PLANNING COMMISSION MEETING STAFF REPORT

NAME OF PROJECT: Mill Canyon Farms

AGENDA ITEM: Final Approval

Subject: Mill Canyon Farms – Final Review

PROPOSED DITCH RELOCATION
PLAN & PROFILE

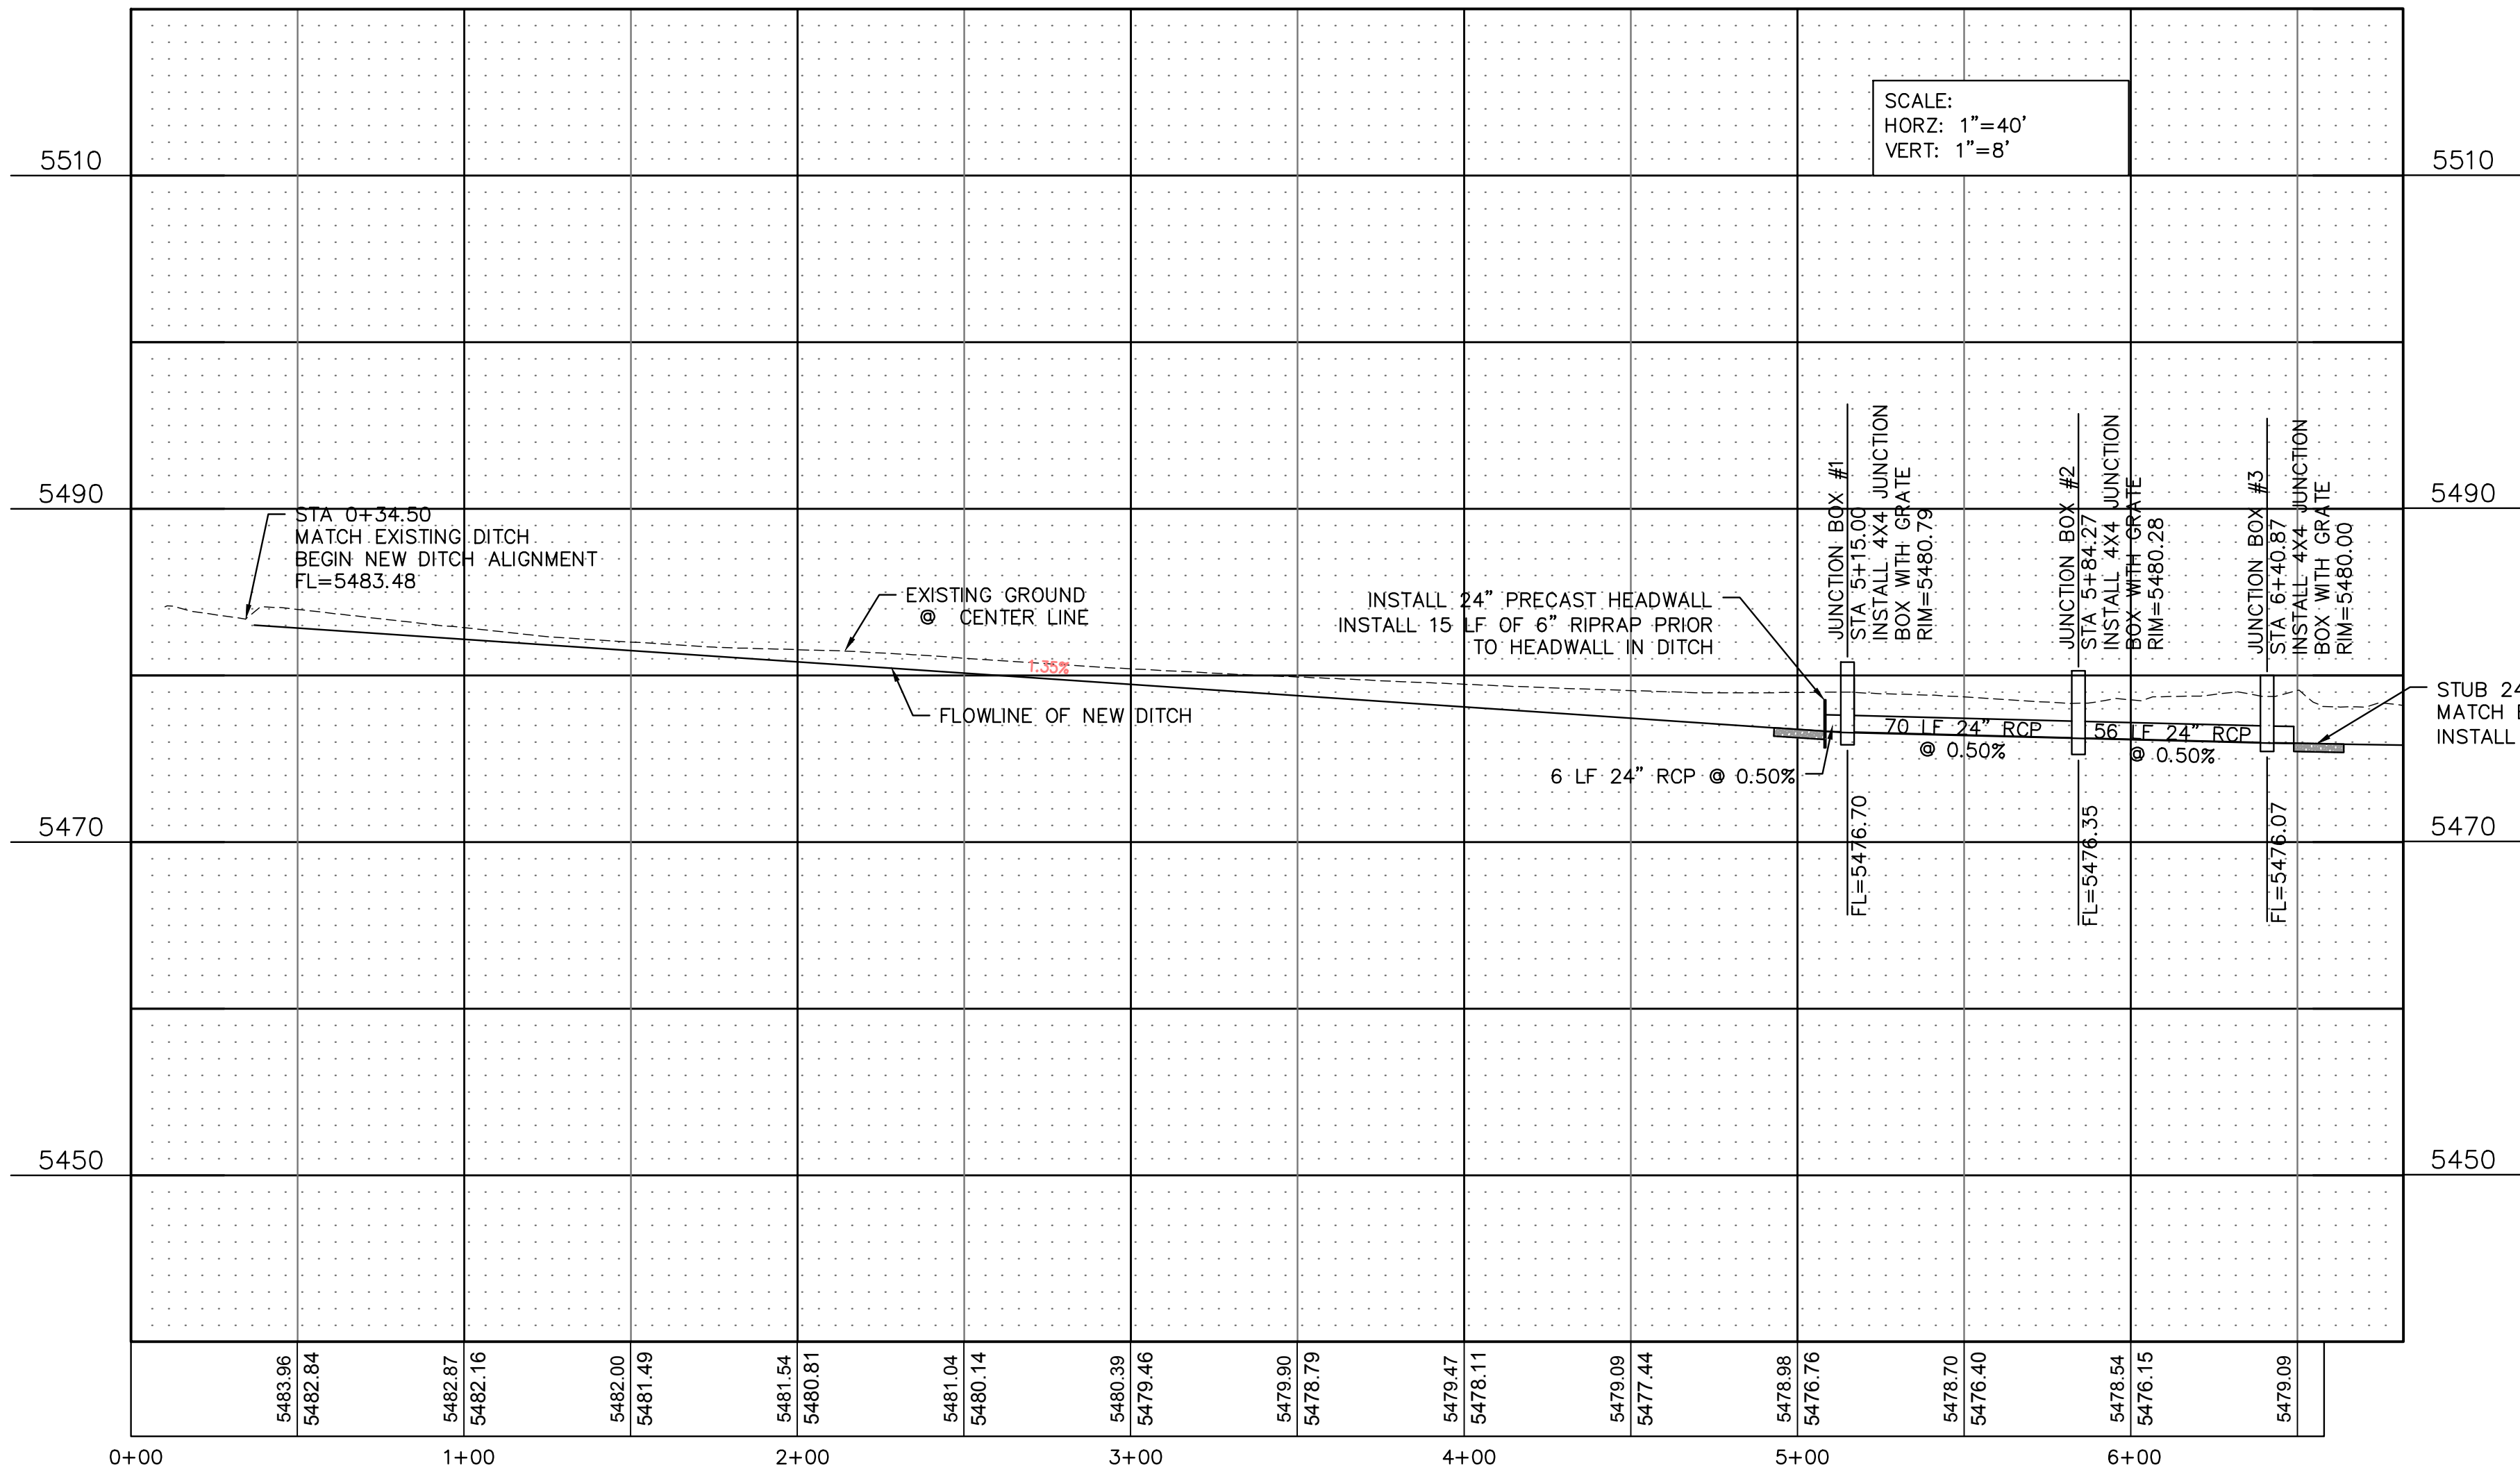
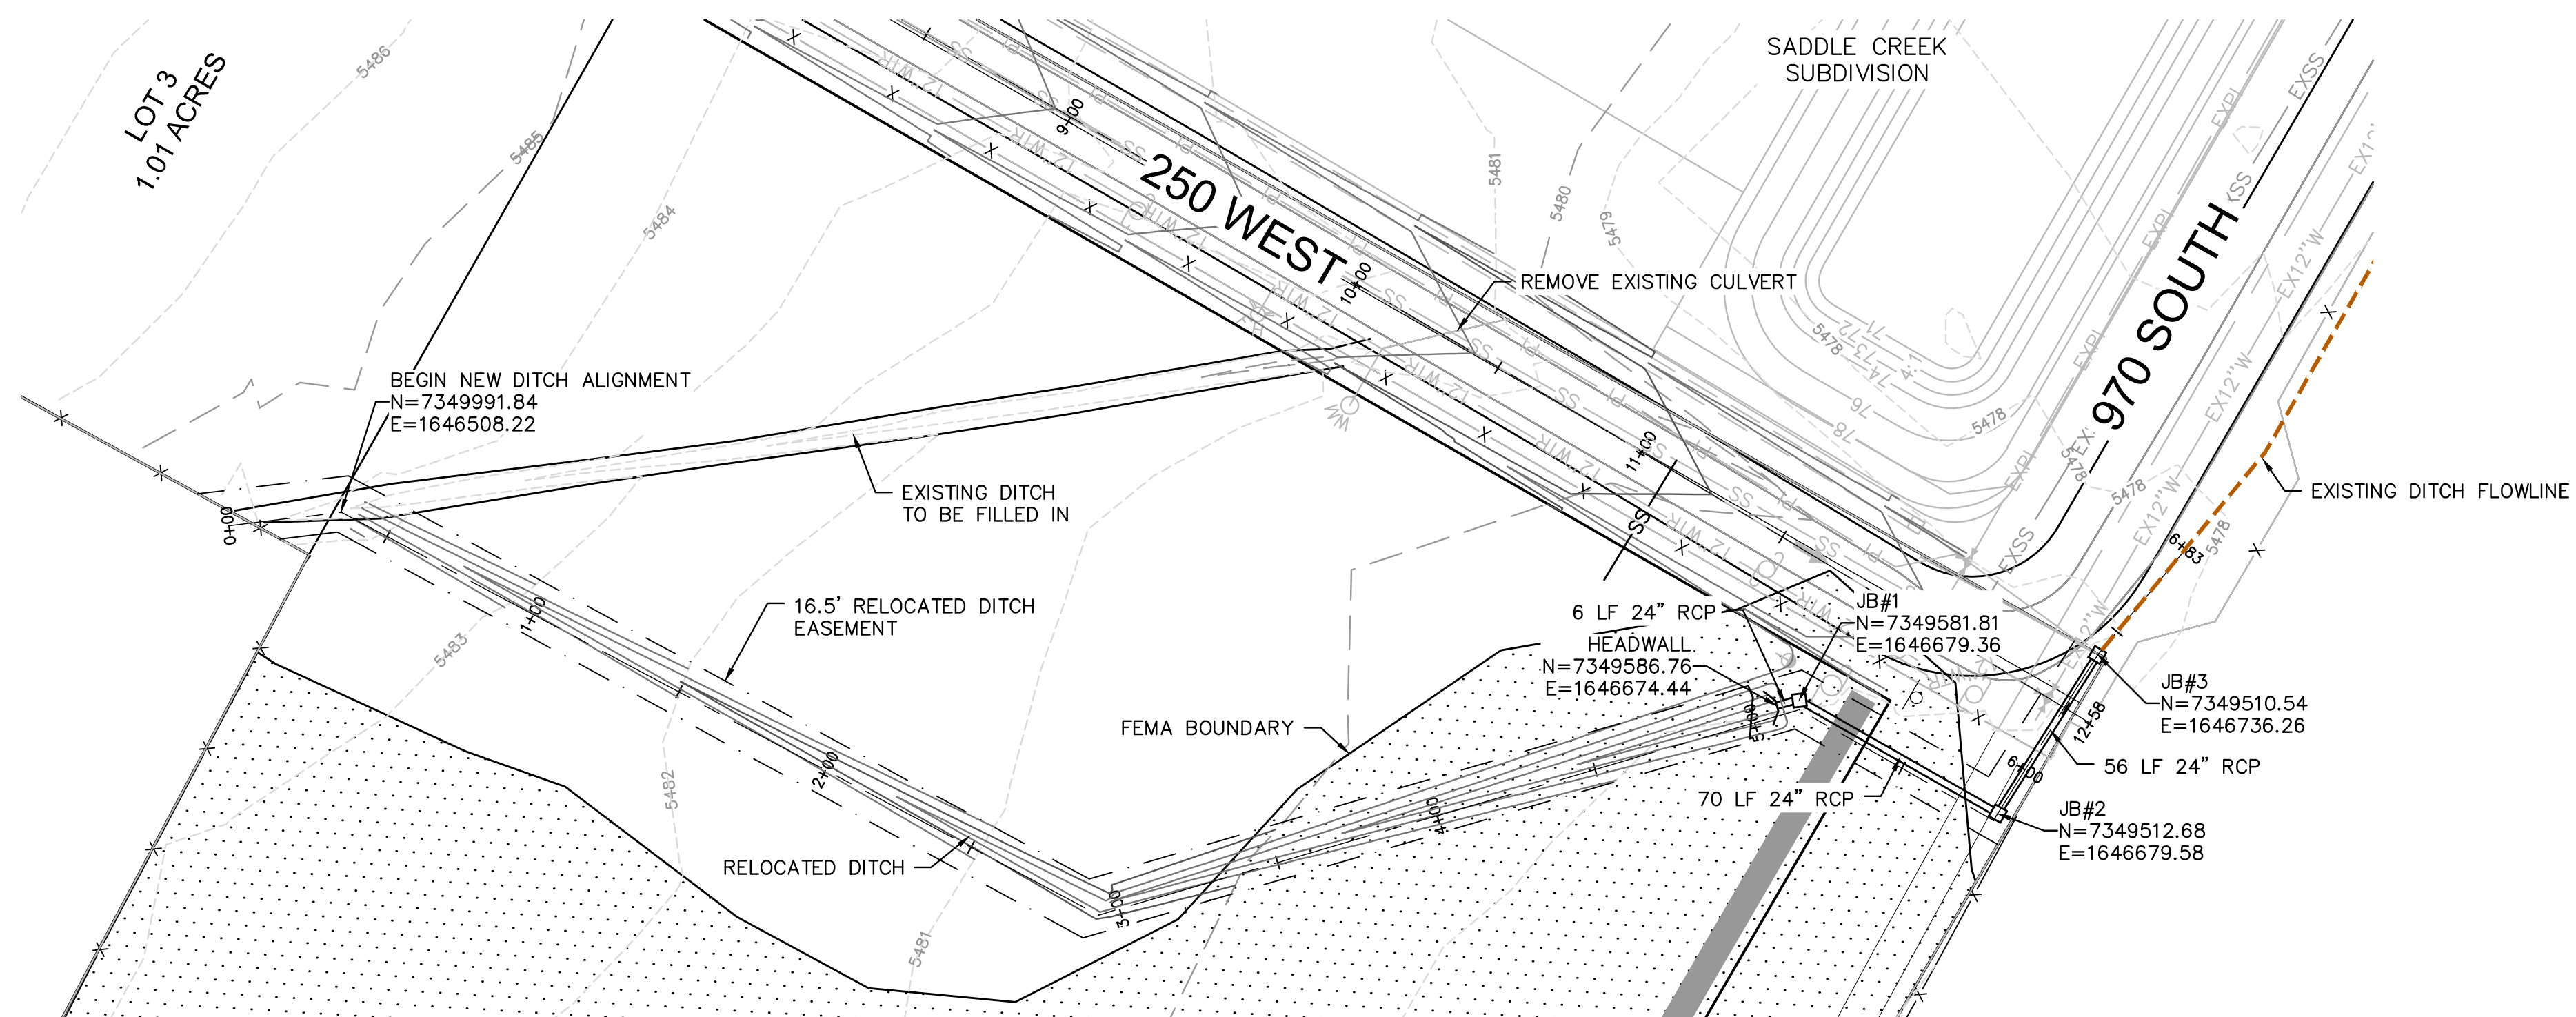
The applicant is also proposing that they reroute the ditch within lot 4 so that it creates less of an impact on the buildable area of the lot. The new ditch easement needs to be shown on the plat. If there are any existing easements, these should be released previous the plat being recorded.

- The development will be serviced by Midway Irrigation Company.
- The development will relocate an existing irrigation ditch in lot 4 and will need to pipe it to the existing ditch in the intersection of 970 South and 250 West.

MILL CANYON FARMS PLAT - 22 OCTOBER 2021

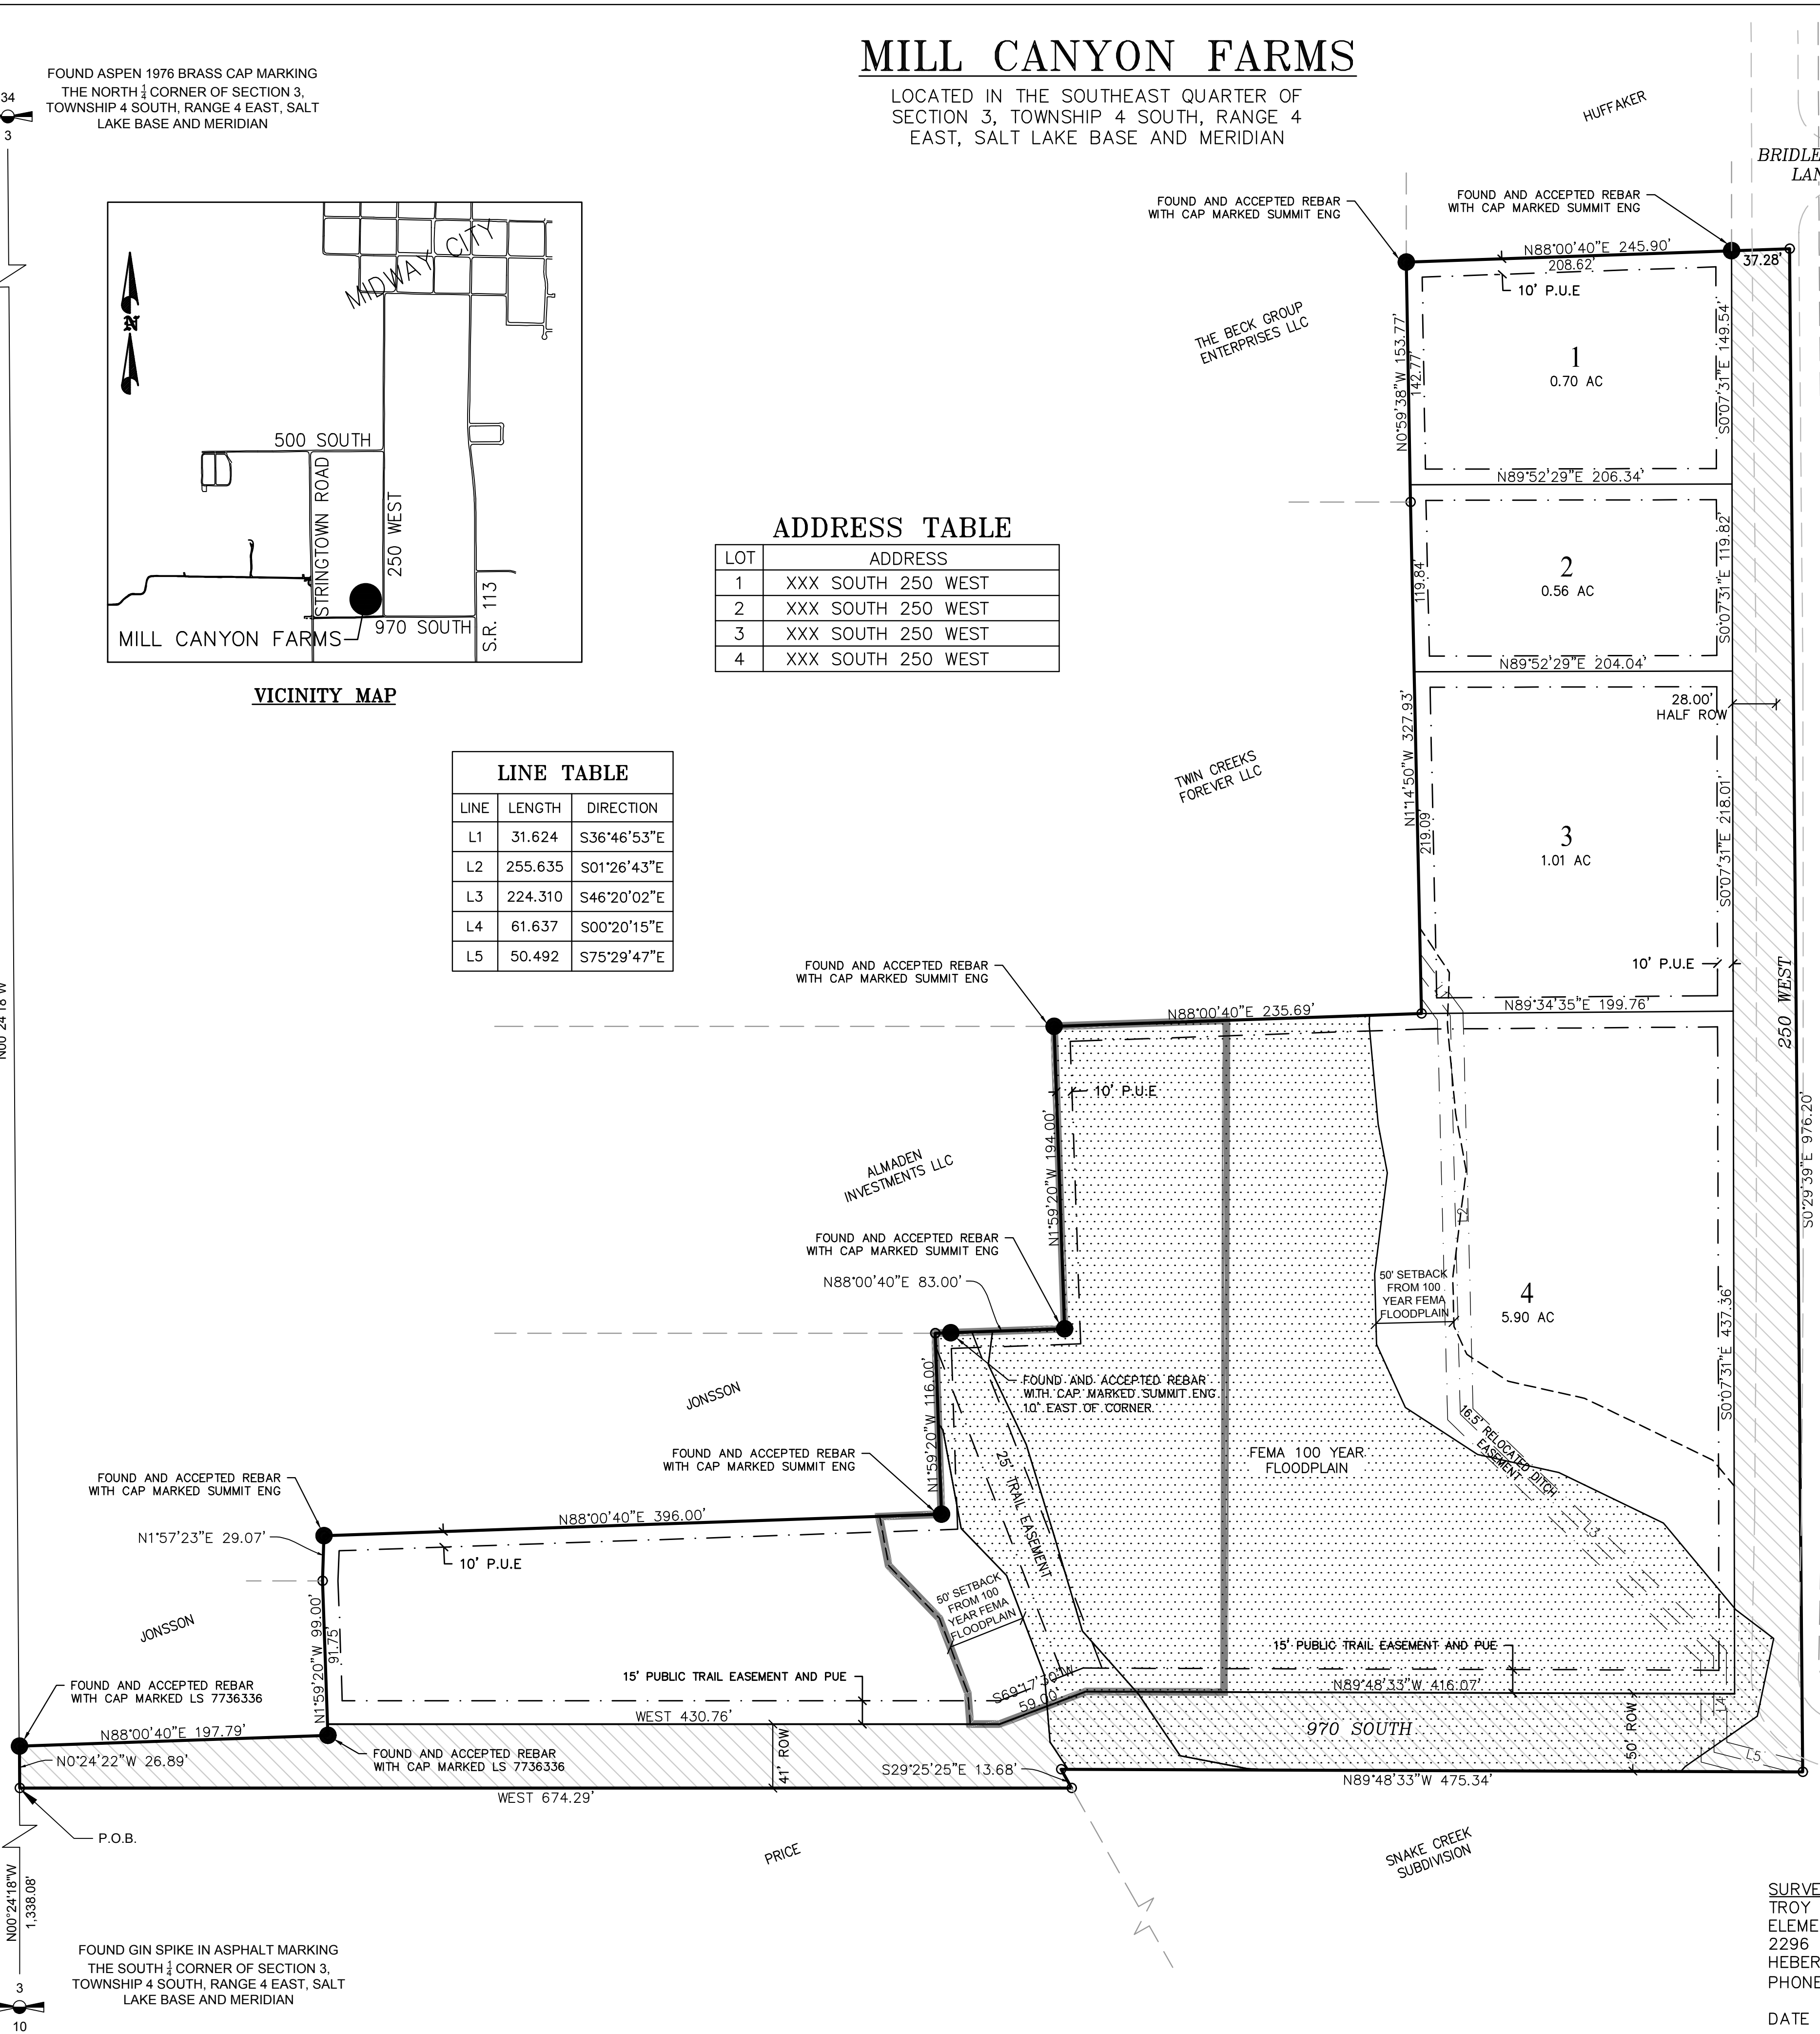
The portion of the lot that counts towards the required open space obligation needs to be clearly identified on the plat along with a note stating that the open space is unbuildable and clarifying what uses can occur on the open space.

- The proposed lot 4 within the development is within a designated FEMA flood plain. A 50' setbacks shall be maintained around all FEMA flood Zones.
